WINDRUSH RESTAURANT, ST KEVINS, HIGH ST, BOURTON ON THE WATER

17/04248/FUL and 17/04249/LBC

Photo No 1 – extraction ducts currently overlooking garden of Living Green at low level

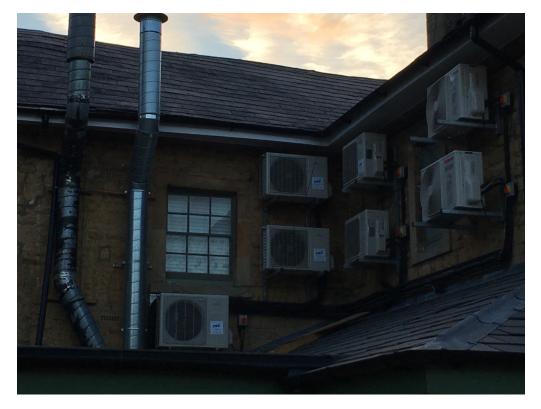
Retention of 3 x low level extraction flues on NW elevation, adjacent to Living Green boundary	Drawing 1304_306 showed just 1 single 200mm dia. extraction flue on this boundary; it is questionable whether even this proposal was feasible, or would have eliminated any nuisance caused to the adjacent owner. The 3 lower level flues which the applicant seeks to retain are of a completely different design. These flues currently serve the larger restaurant activity. These flues emit noise and odours throughout the entire period the restaurant is open (including into late evening) and which render the adjacent owners' garden completely unusable for its designed purpose. They could be considered a statutory nuisance and are completely unacceptable in terms of their impact. The fact that the applicant claims these are now necessary to operate the scale of the current restaurant activity is completely irrelevant. It is a requirement of the planning process that a development can only be permitted if it demonstrates it will not adversely impact upon neighbouring businesses and properties.

Objection: In the event the business cannot re-locate the flues away from this boundary or reduce the noise and odour impact from the flues to a level deemed acceptable by Environmental Health (eg via a carbon filtration system and other means), and which will not prevent use of the neighbouring garden for its usual purpose, permission should be refused and the applicant required to operate only in a way that will not result in this nuisance. Given the scale, frequency and duration of the odour and noise intrusion from these flues and the fact that this nuisance has been created as a result of unauthorised development, their removal should be enforced immediately to prevent the unacceptable nuisance continuing throughout the summer season. Comment: It can be considered a major failing of the planning and appeal process that has resulted in the change of use from newsagent to take-away being permitted at appeal without appropriate conditions being attached and enforced to address issues which are a direct result of the completely
